GEOTECHNICAL INVESTIGATION ORLEANS LEVEE DISTRICT PONTCHARTRAIN BEACH FLOODWALLS AND LEVEES NEW ORLEANS, LOUISIANA

ADDENDUM NO. 4
Pontchartrain Beach
Flood Protection Improvement Project
Phase II
Proposal No. 2040-0375
Lakefront Capital Improvement Program
The Board of Levee Commissioners
of the
Orleans Levee District
January 28, 1987

ADDENDUM NO. 1
Pontchartrain Beach
Flood Protection Improvement Project
Phase II
Proposal No. 2040-0375
Lakefront Capital Improvement Program
The Board of Levee Commissioners
of the
Orleans Levee District
January 22, 1987

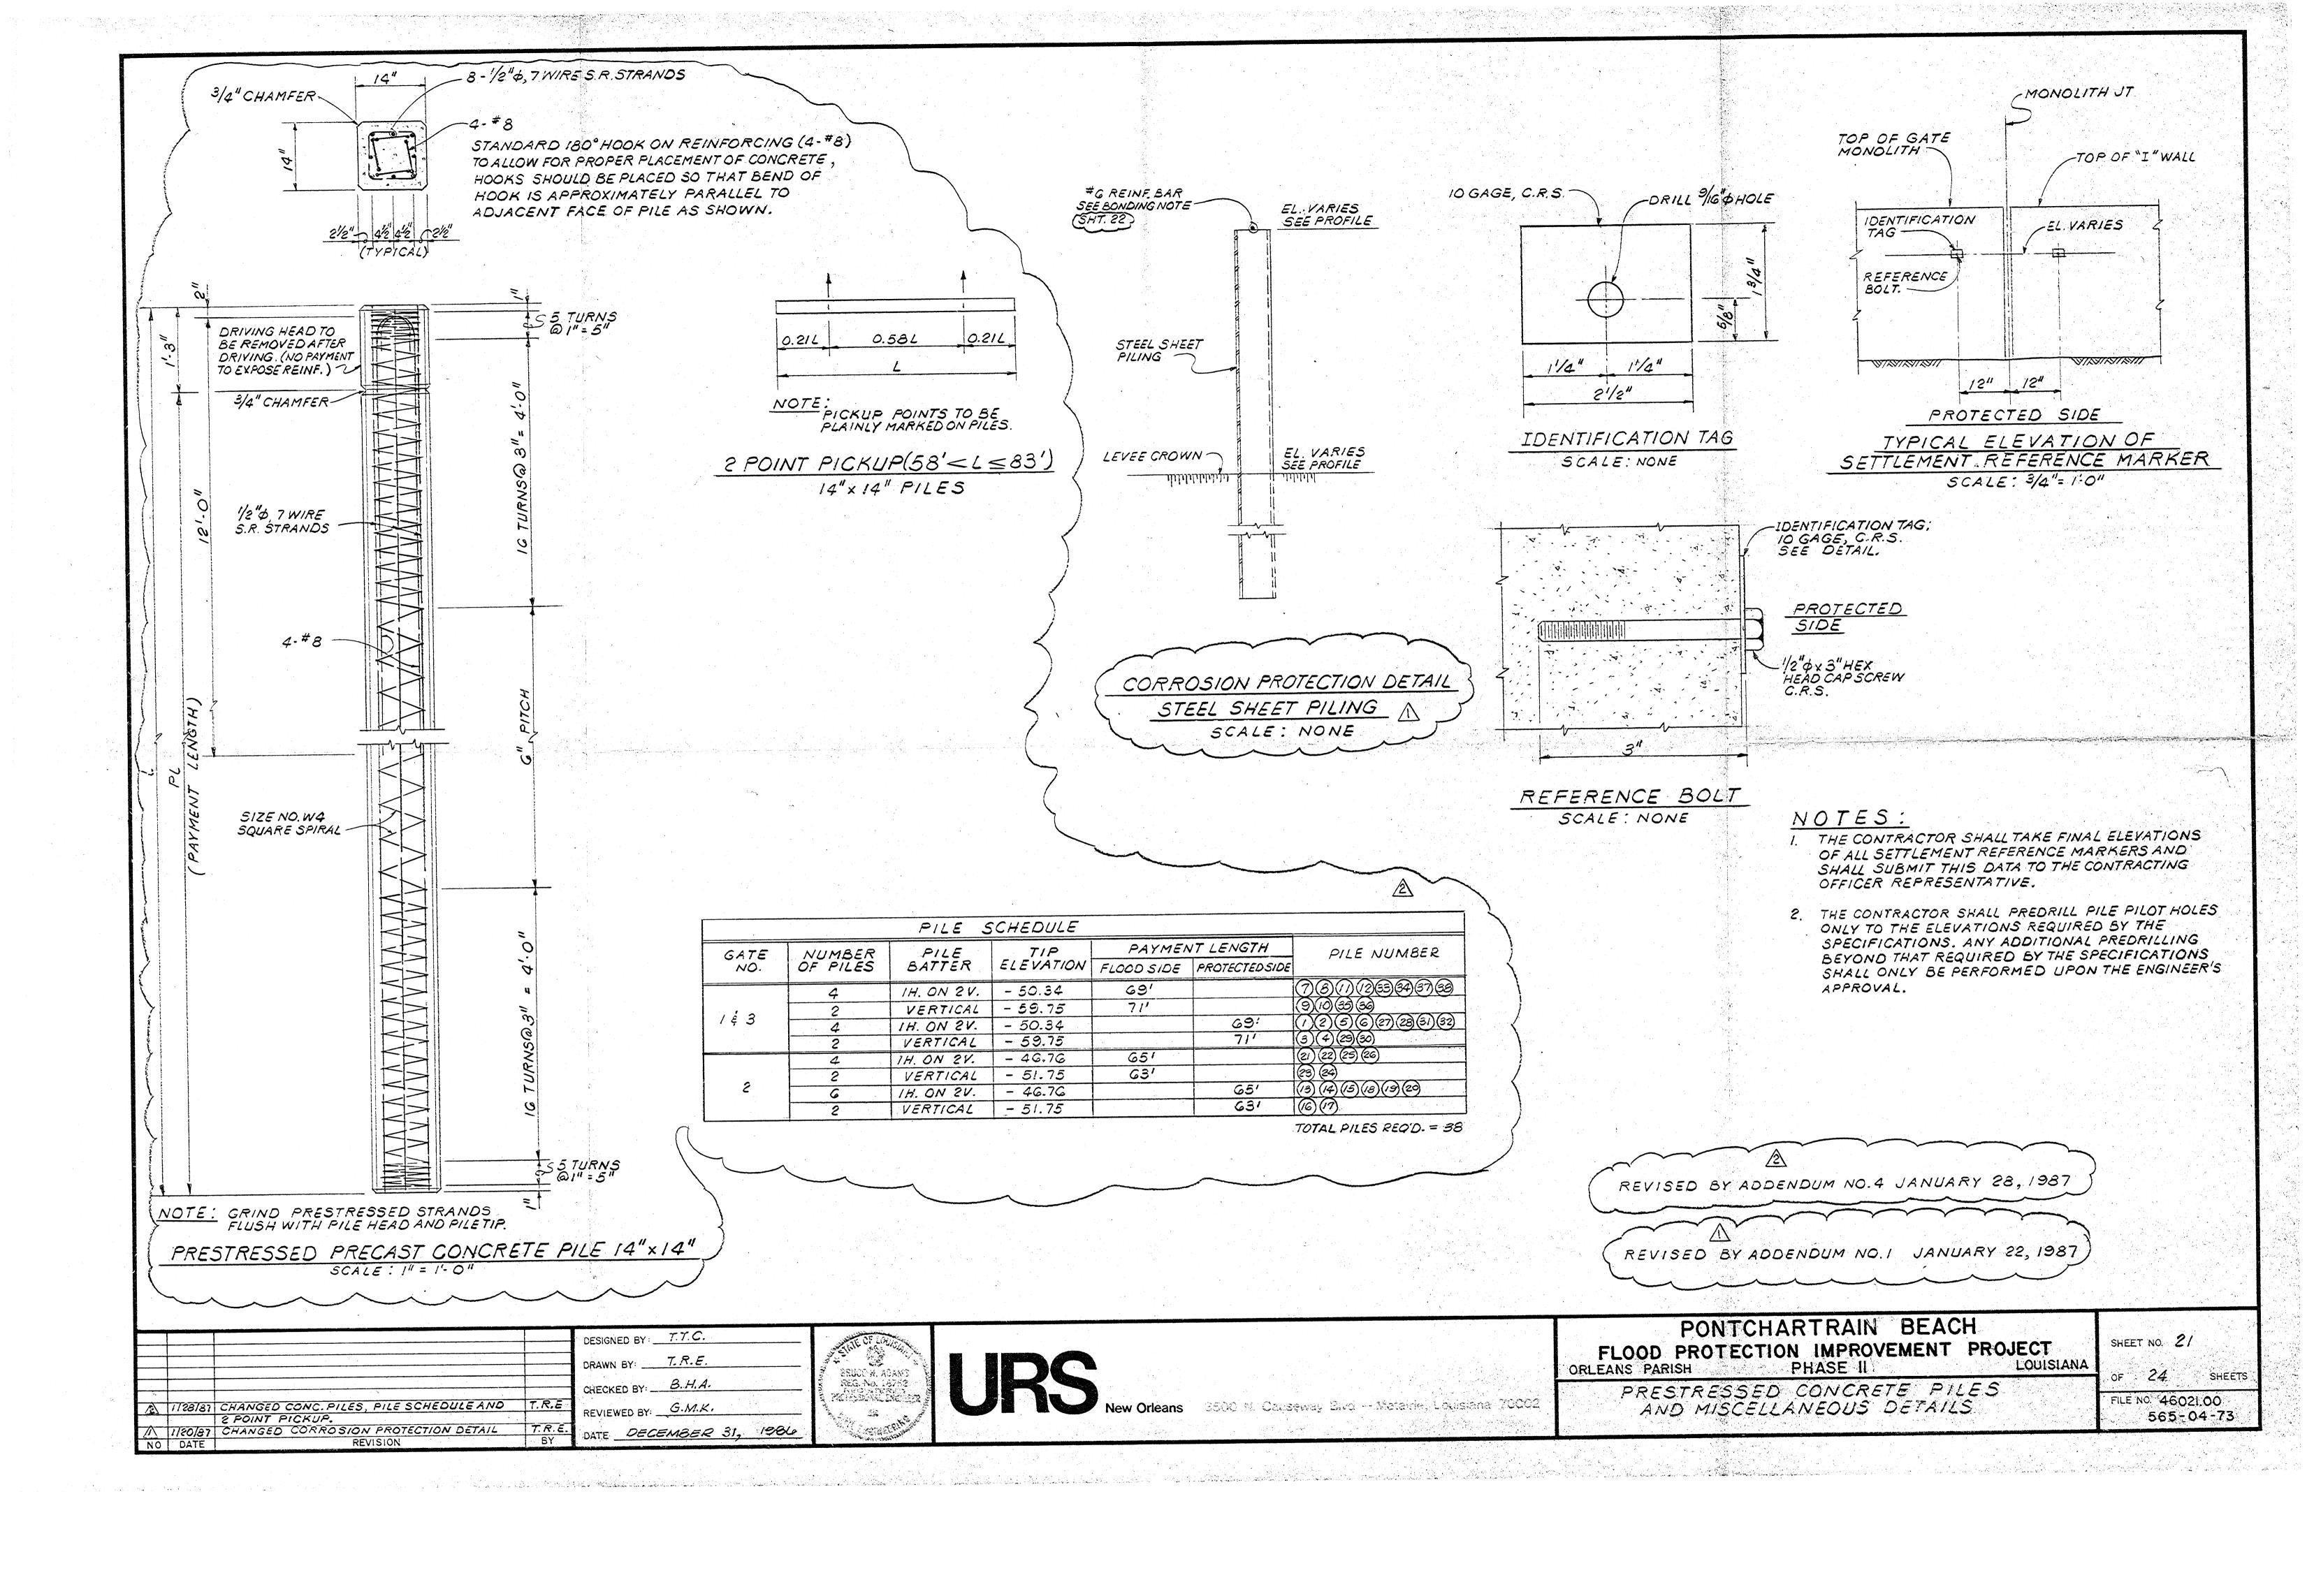
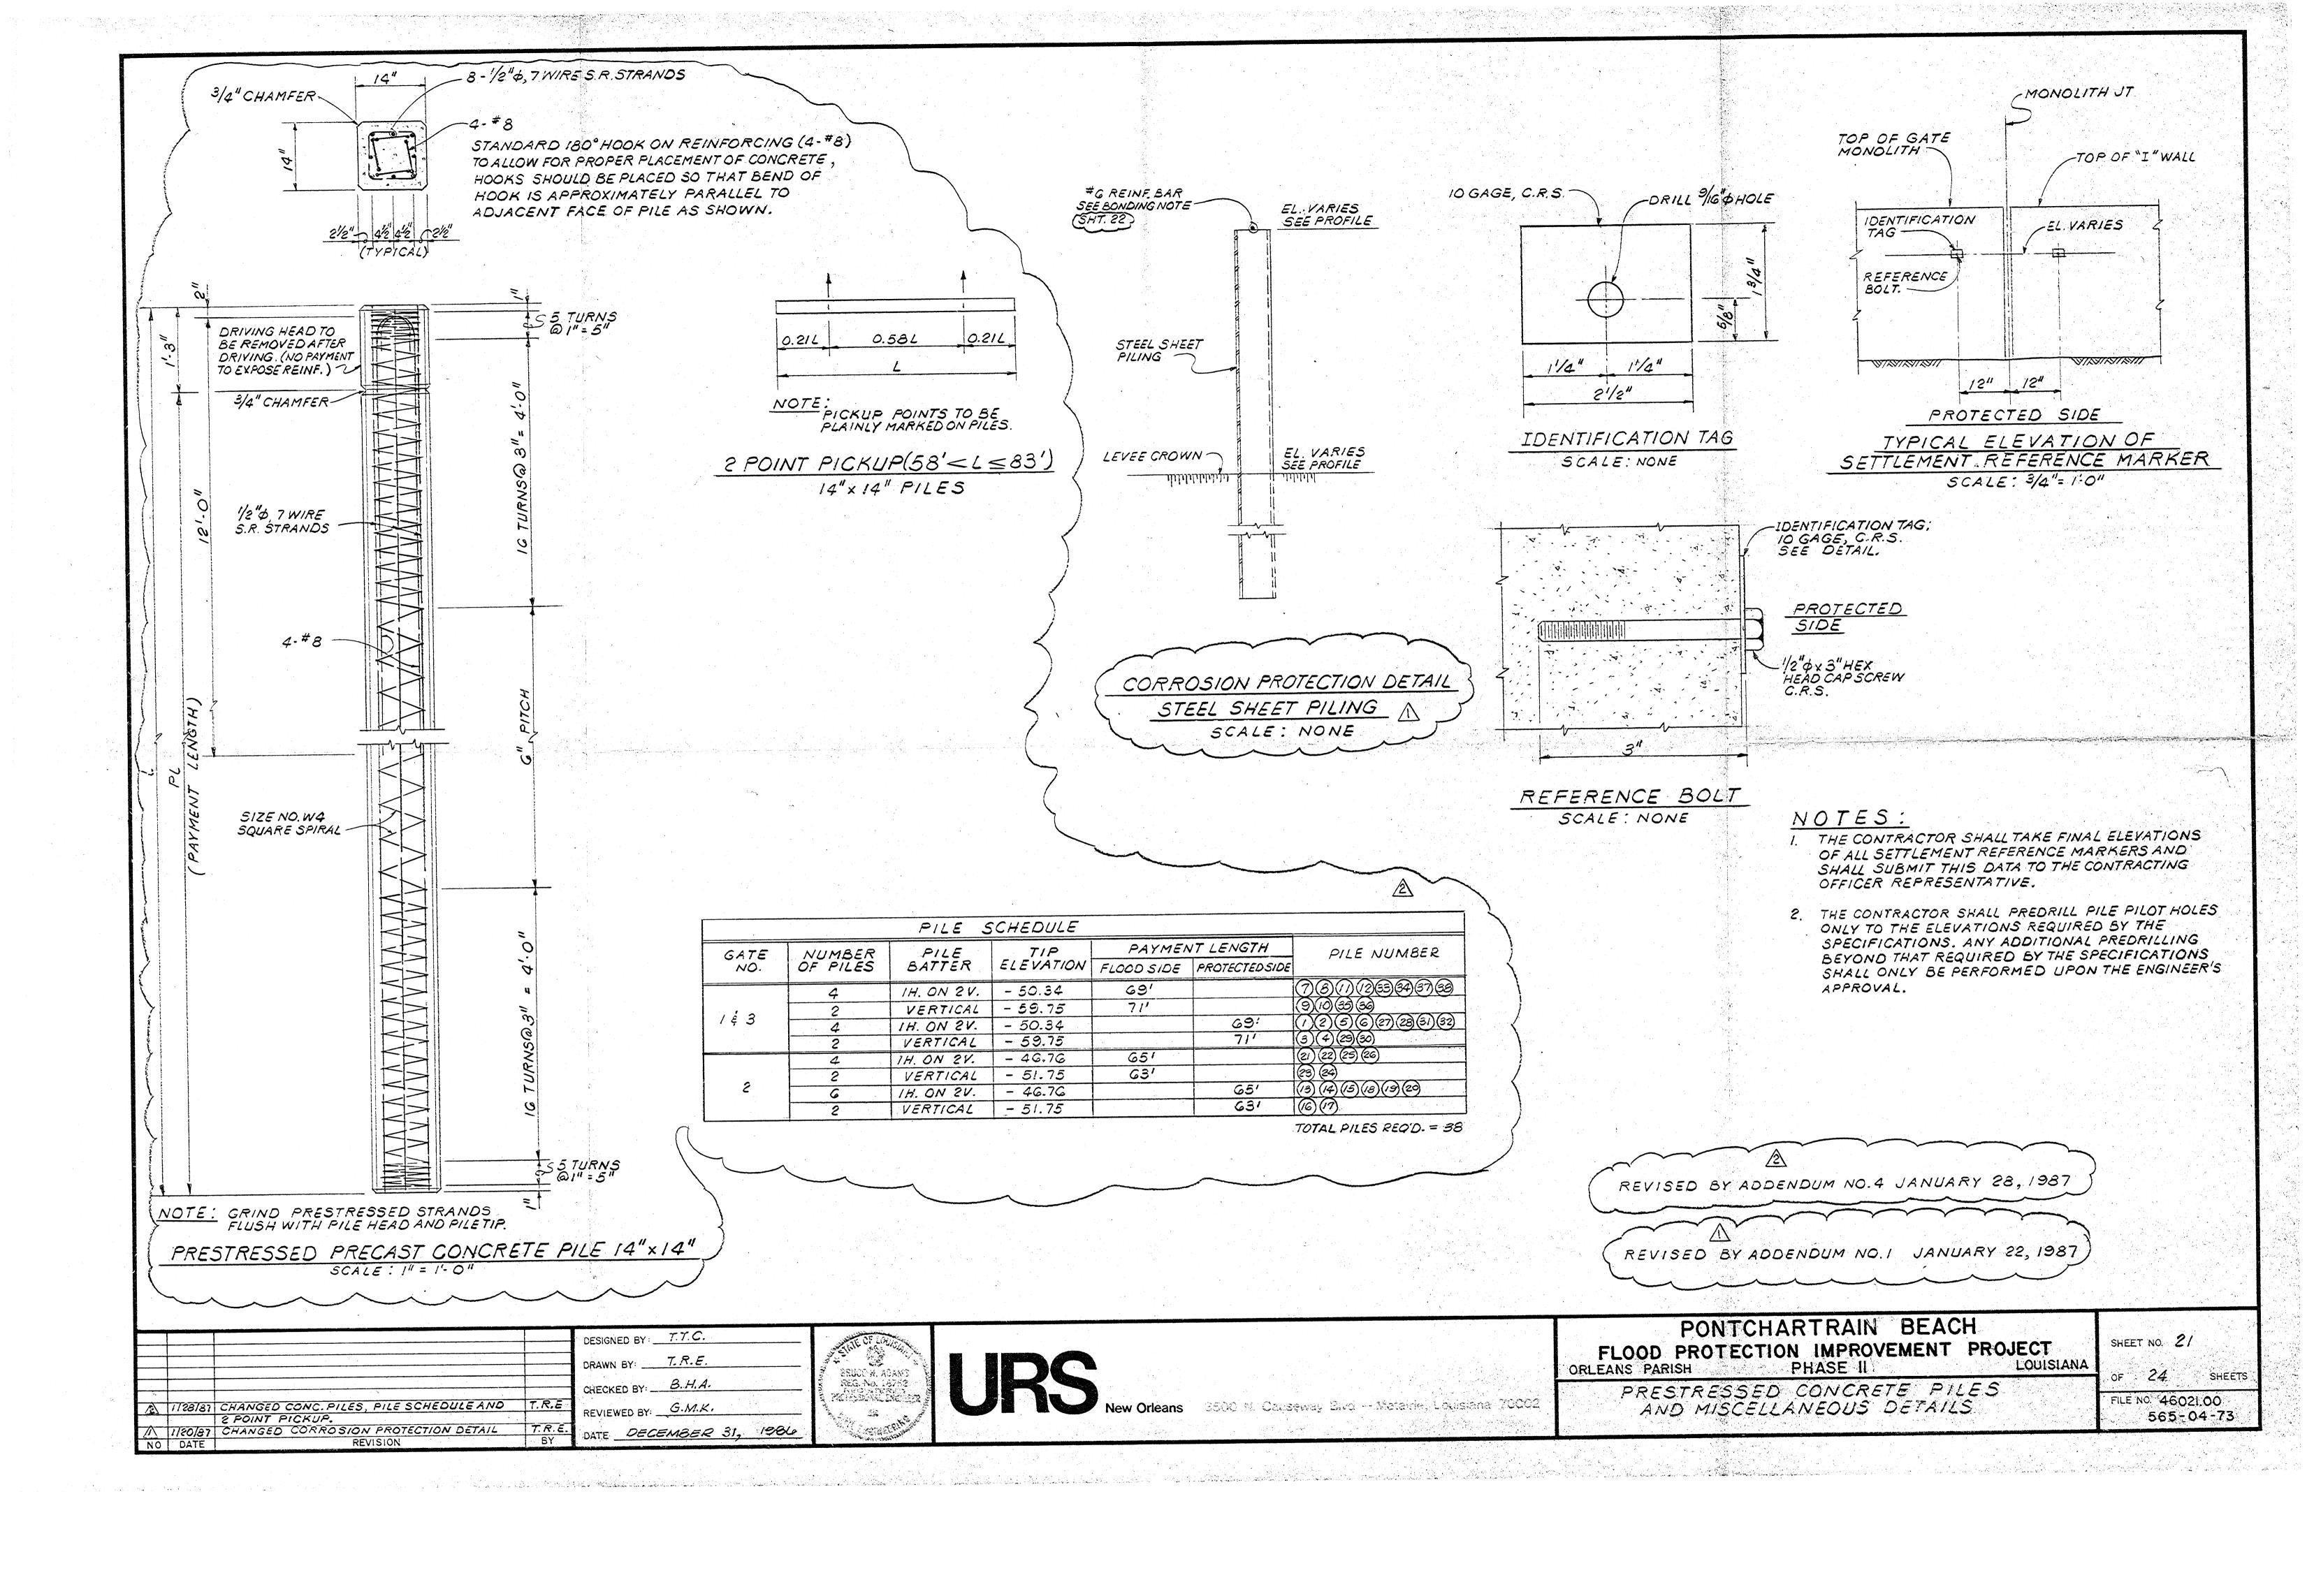
- Refer to Addendum No. 3 dated January 23, 1987 and Addendum No. 1 dated January 22, 1987. Disregard Item No. 2 of Addendum No. 3, and concerning Item No. 10 of Addendum No. 1, replace Sheet 21 Revised by Addendum No. 1 January 22, 1987, with the enclosed Sheet 21 Revised by Addendum No. 4 January 28, 1987 and Revised by Addendum No. 1 January 22, 1987.
- A. Refer to Addendum No. 3 dated January 23, 1987. Disregard Item Nos. 4 and 5 of Addendum No. 3 as well as page E-4 of the <u>Bid</u> <u>Schedule</u> as revised by Addendum No. 3.
 - B. Refer to Section 5, <u>Prestressed Concrete Piles</u>, Part 5-4, <u>Measurement and Payment</u> (page 5-7) of the Specifications. In part 5-4.B (page 5-8), <u>Basis of Payment</u>, after:

- 3. Refer to the project drawings. Change any references therein regarding the Prestressed Precast Concrete Piles or Piling from 12" square or 12" x 12" to 14" square or 14" x 14".
- 4. Refer to Section 5, <u>Prestressed Concrete Piles</u>, of the Specifications.
 - A. In the first sentence of paragraph 5.2.A.l (page 5-2), change "... 12-inch by 12-inch.", to "... 14-inch x 14-inch."
 - B. Change the third sentence of paragraph 5.2.B.7.a (page 5-4), to read, "The piling may be removed from the casting bed to nearby storage anytime after transfer of stress provided the maximum length does not exceed 83 feet for 2-point pickup or 58 feet for 1-point pickup."
 - C. In paragraph 5-4.B.l (page 5-7), change the reference '..."Piling, Concrete, Precast, Prestressed, 12-inch,"...', to '..."Piling, Concrete, Precast, Prestressed, 14-inch," for either Vertical Piling or Batter Piling,...'
